17<sup>th</sup> September 2014

**Subject: Grenfell Tower Grenfell Road London W11 1TQ**

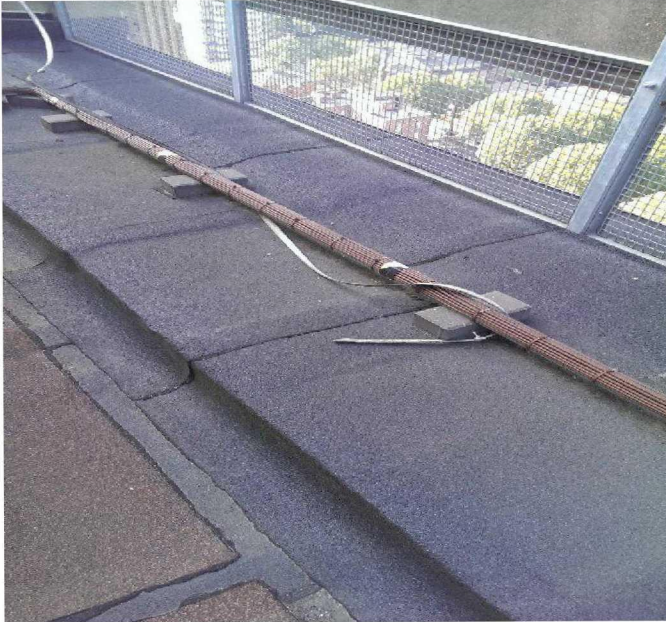
The controls for the smoke vents in the finger blocks are still located in the old reception area.

16. What are the access arrangements to these smoke control panels, especially when the contractors are off site?

Cables on the floor and drains blocked

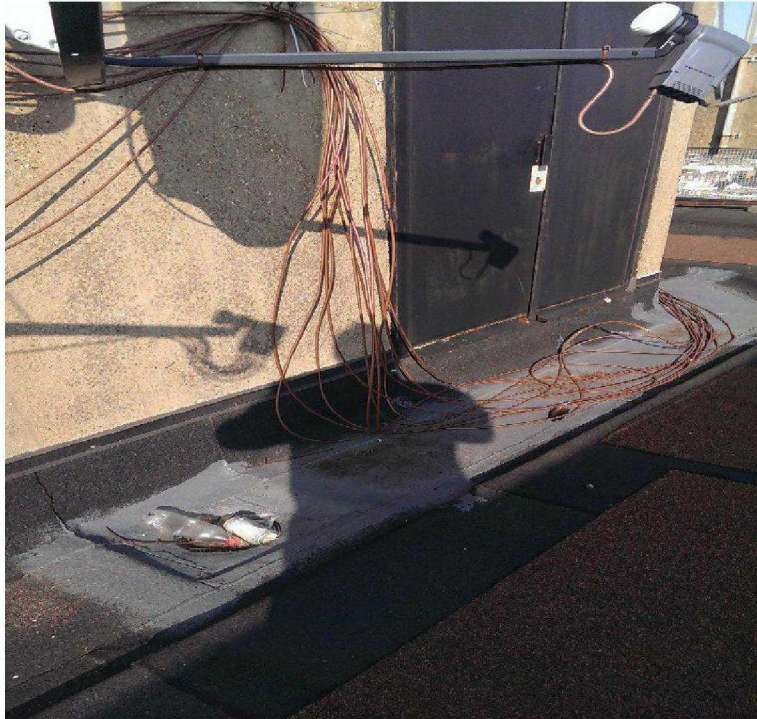
Work has been undertaken by "SCCI Alphatrack" to relocate satellite disks positioned on the face of the building to the roof level, the lightning protection system on this building has been wilfully damaged and this company have left cardboard boxes at the roof level obstructing the means of escape. The door to the external roof is damaged and does not close, there is waste and rubbish blocking the drains at the roof level and the cables are obstruction the doors to the plant areas and laid on the floor causing a

17. The installed lightning protection system on this building should be repaired immediately and a completion and or a commissioning certificated issued by the contractor to state that the system is in full working order.
18. All the rubbish should be removed from the roof level and the drains unblocked etc.
19. The door to the external roof area should be repaired or replaced and locks etc fitted so that it can be secured shut.

Cables

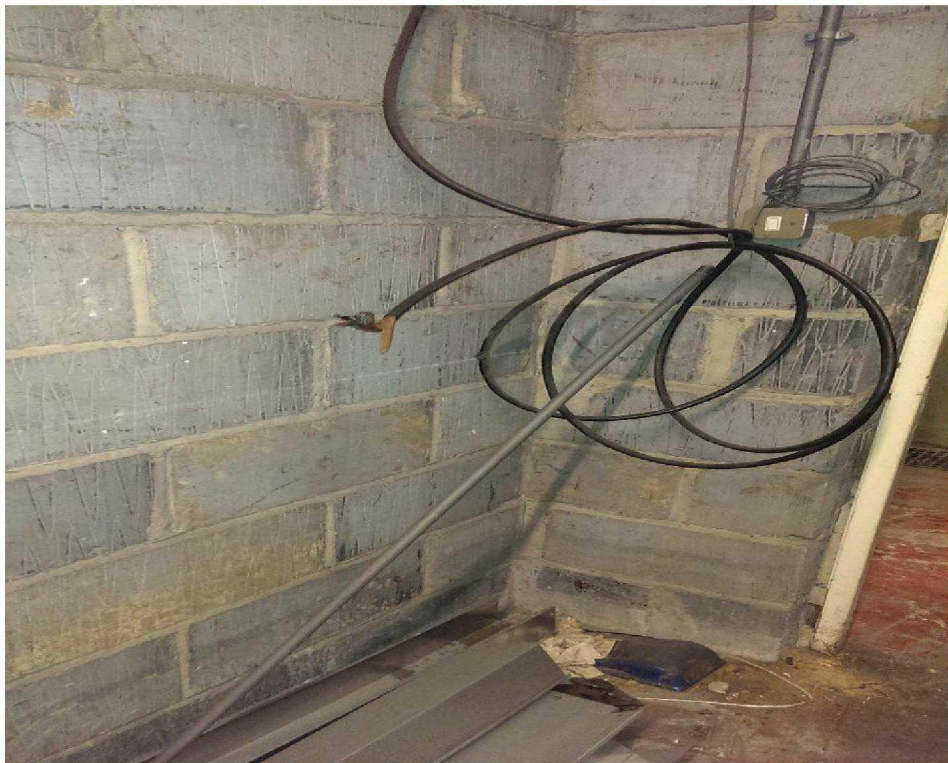
Work is being undertaken in the basement area of this building, new boilers will be installed etc, the door at the base of the staircase is damaged and there are electrical cables hanging down from the ceiling etc.

22. Can it please be confirmed by the contractor that all cut and hanging electrical cables in the basement area are not live?

23. The damaged door and door frame at the base of the staircase down to the basement should be repaired or a new door set installed.
24. The amount of combustible waste in the basement area should be kept as low as possible, with rubbish and waste removed at regular intervals, I would recommend that the contractor is asked to tidy up and remove combustible waste from this basement area.
